## SS 754 - WST 2023 49X and 47X Web Mounted 5th Wheel Ramps

Western Star 49X and 47X vehicles equipped with Holland air sliding 5th wheels (Family Data Code 578-A02) and frame rail web mounted ramps.

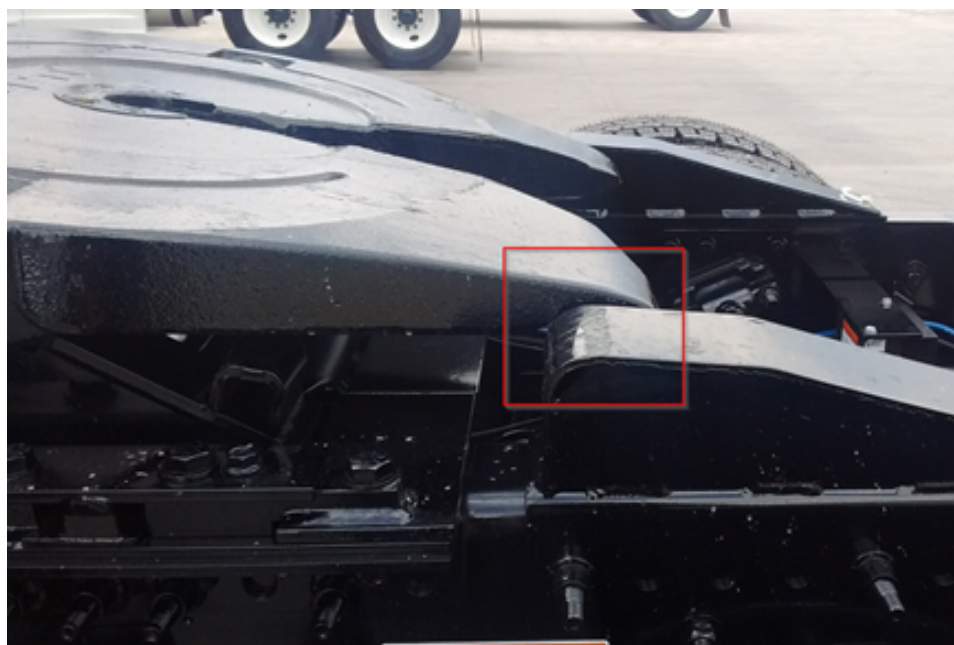
On certain tractor configuration vehicles, when the 5th wheel is slid aft, there is potential for the 5th wheel top plate to contact the 5th wheel ramps. This interference restrains the 5th wheel top plate from reaching the designed lowest position when the tractor is in the unloaded configuration. ( See picture below).

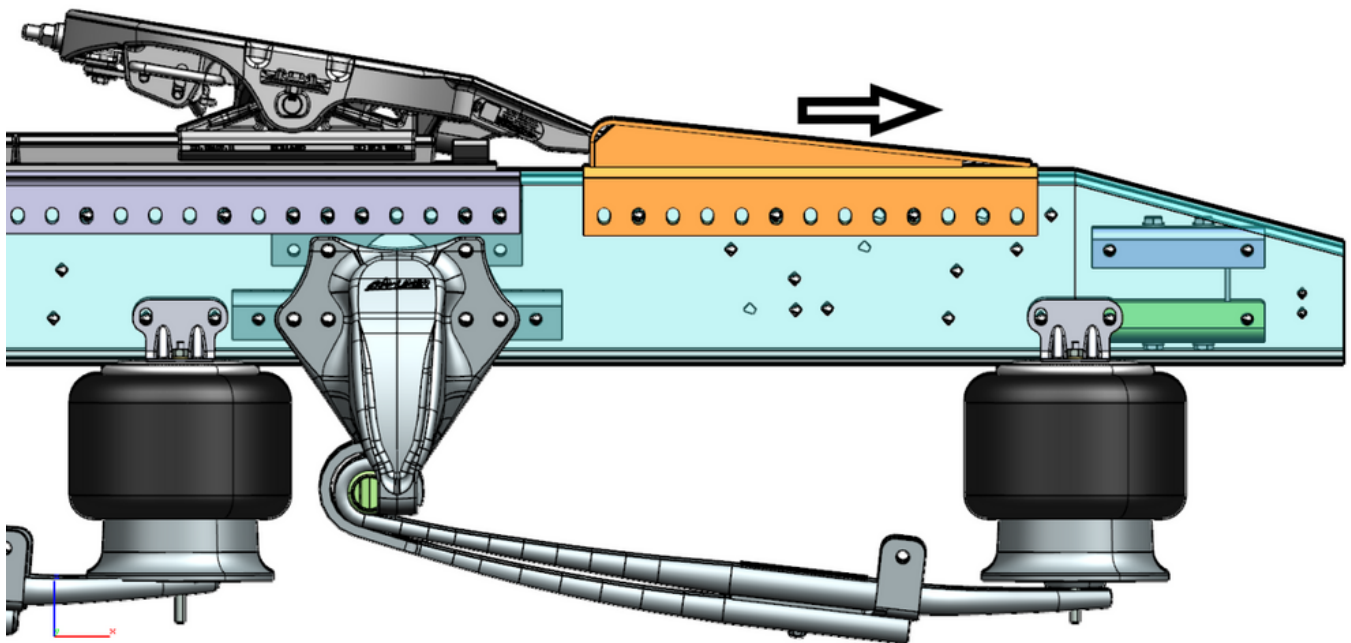
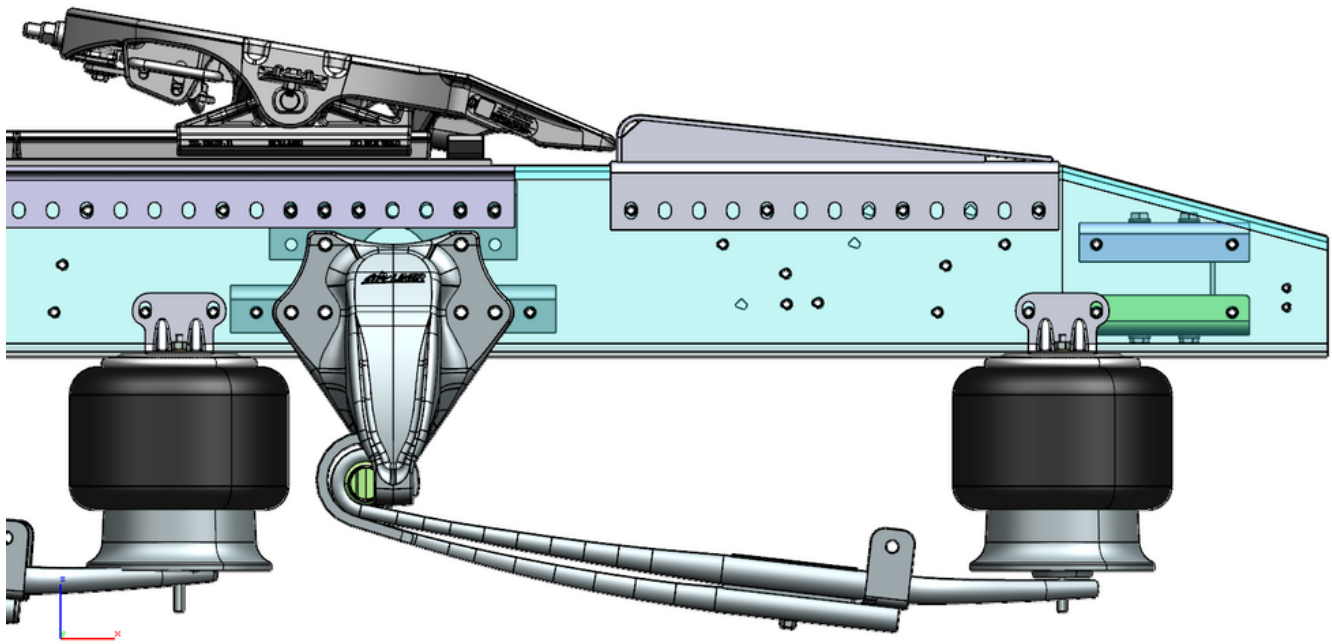
To avoid the symptoms reported above, web mounted 5th wheel ramps were modified at the truck manufacturing plant. A potential interference issue is possible when a dealer/customer orders new unmodified replacement 5th wheel ramps.

- Move the replacement 5th wheel ramps one frame rail grid hole aft to provide the required clearance. (See pictures below)
- If moving the replacement 5th wheel ramps one frame rail grid hole aft is not possible, modify the replacement ramp width to provide required clearance to the 5th wheel top plate. Use the width of the original factory installed ramps as a guide for the modification required.
